ADDENDUM No. 2

RFP No. 26-11

N. University and Thayer Improvements

SHEET No. 22 OF 80

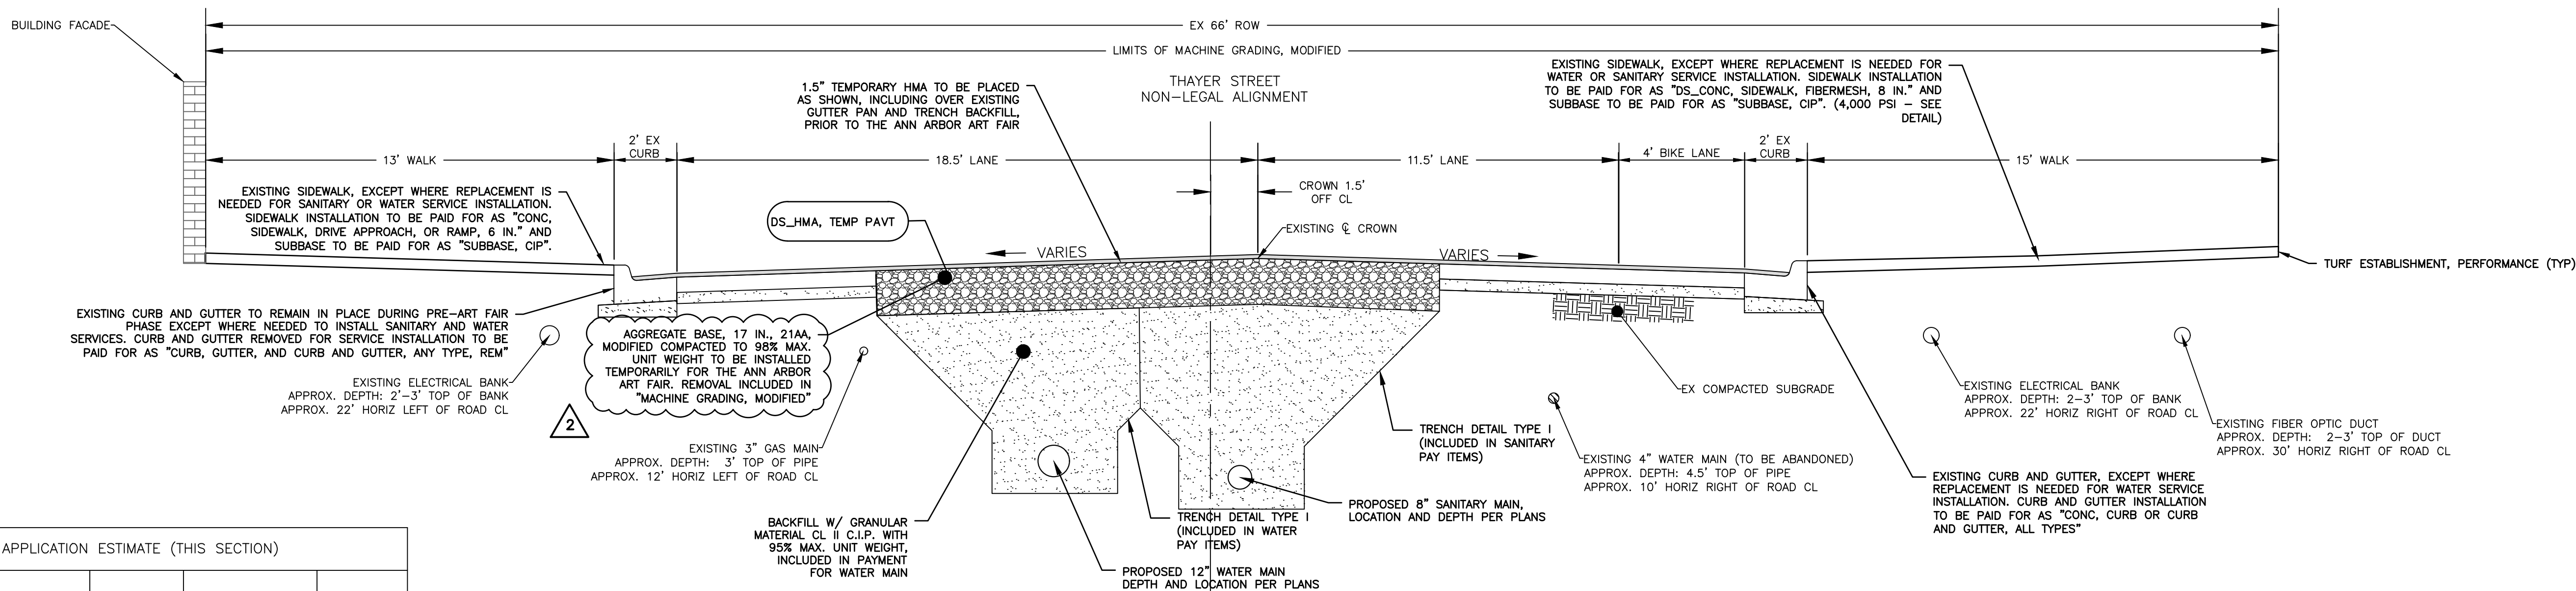
Plan Sheet 22	Note for aggregate base for utility trench has been revised from Aggregate Base, 15 in, to 21AA to Aggregate Base, 17 in, 21AA.
Plan Sheet 40	Storm sewer alignment revised between Structure R-19 to R-20, and R-19 to R-22.
Plan Sheets 42-43	Plan and profile updated to reflect changes between Structure R-19 to R-20, and R-19 to R-22. The rim elevation for structure R-6 was also updated.
Plan Sheets 44-48	“CONC, SIDEWALK, DRIVE APPROACH, OR RAMP, 6 IN., HIGH EARLY” & “CONC, SIDEWALK, DRIVE APPROACH, OR RAMP, 8 IN., HIGH EARLY” added to construction key. Drive entrances modified to reflect utilization of high early concrete and quantities revised to reflect these changes.
Plan Sheet 49	Updated to reflect revised light pole locations.
Plan Sheet 52-54	Updated to reflect revised light pole locations. The valve box rim elevation was also revised.
Plan Sheet 64-66	Light pole location and conduit alignment revised.

Question 28: On sheet 22, for the cross section of the pre-art fair phase on Thayer St, it shows 15" 21AA aggregate base to be placed within the trench areas. How is this aggregate base paid for? There is no current item in the bid item list.

Answer 28: The pay item was changed to 17" 21AA aggregate base.

2023-023-69

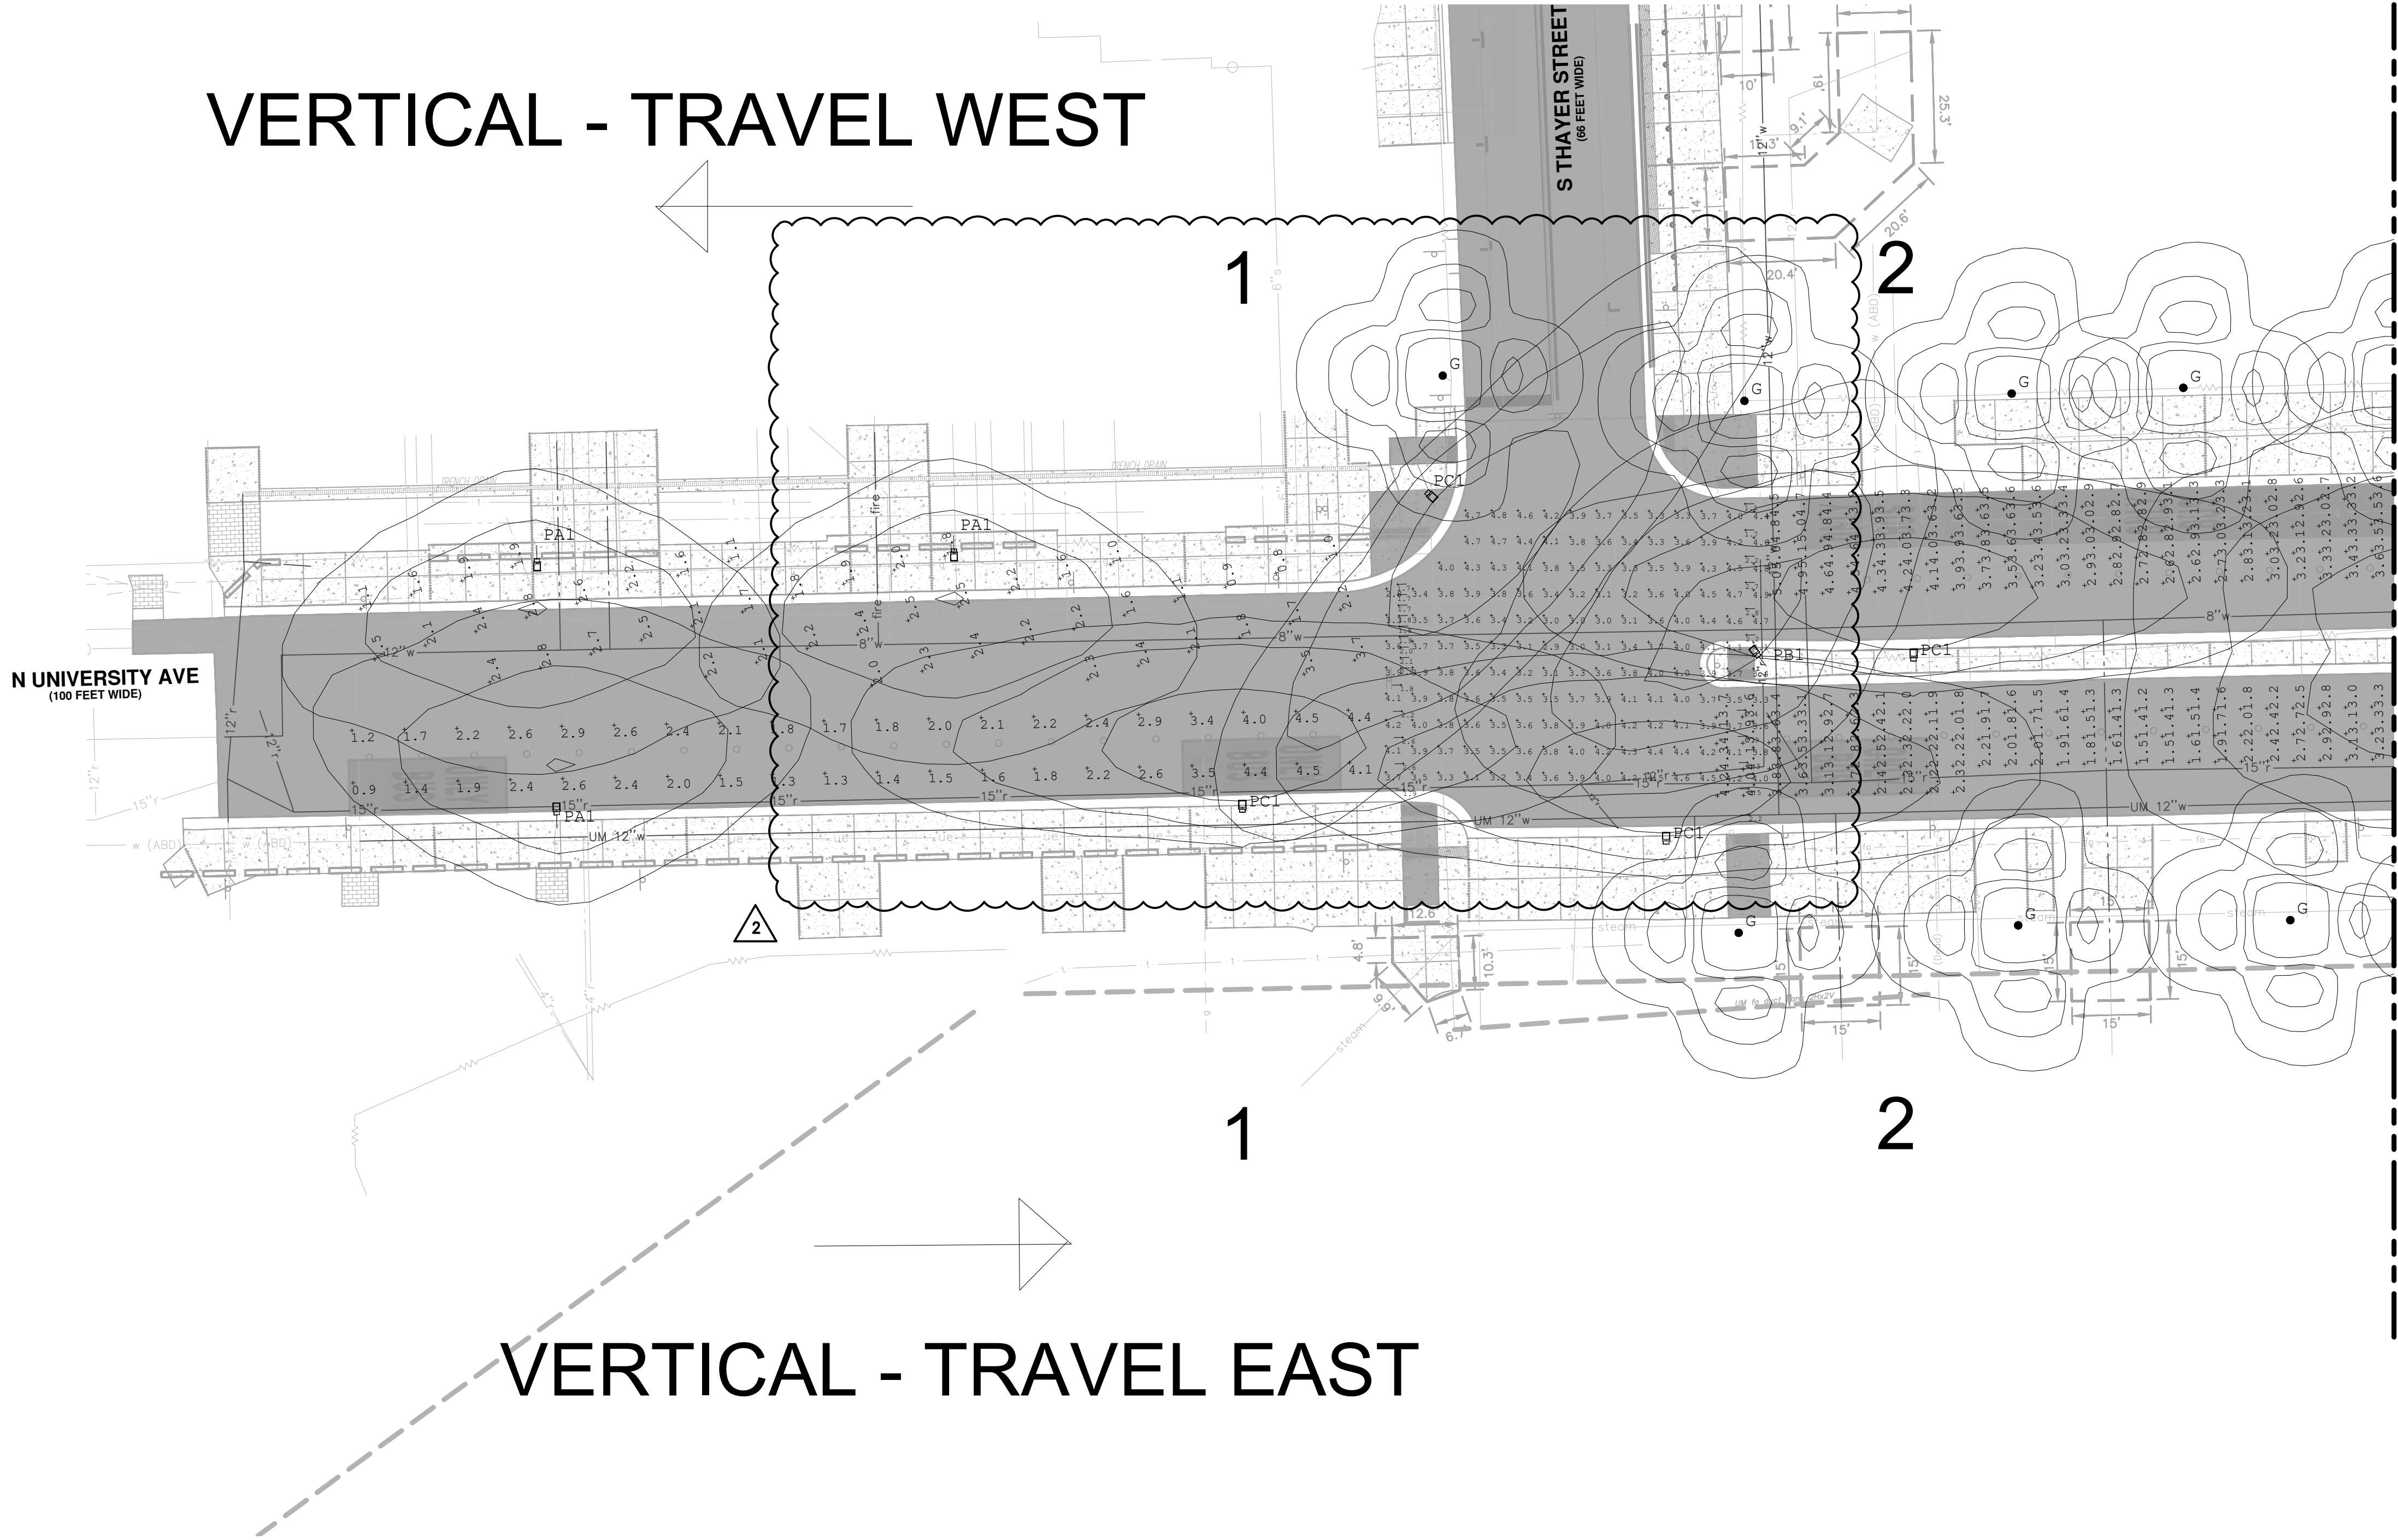
Plan Sheet 67	Luminaire schedule and fixture wattage and distribution revised.
Plan Sheet 69-70	Lighting calculation summary and luminaire schedule updated to reflect revised light pole locations and fixtures. The photometric plan was updated to reflect revised light pole locations and fixtures.
Sewer Inspection Report	Reports for sewer inspection for storm and sanitary in the project limits has been added as part of this addendum. See Question 12 in Section II.
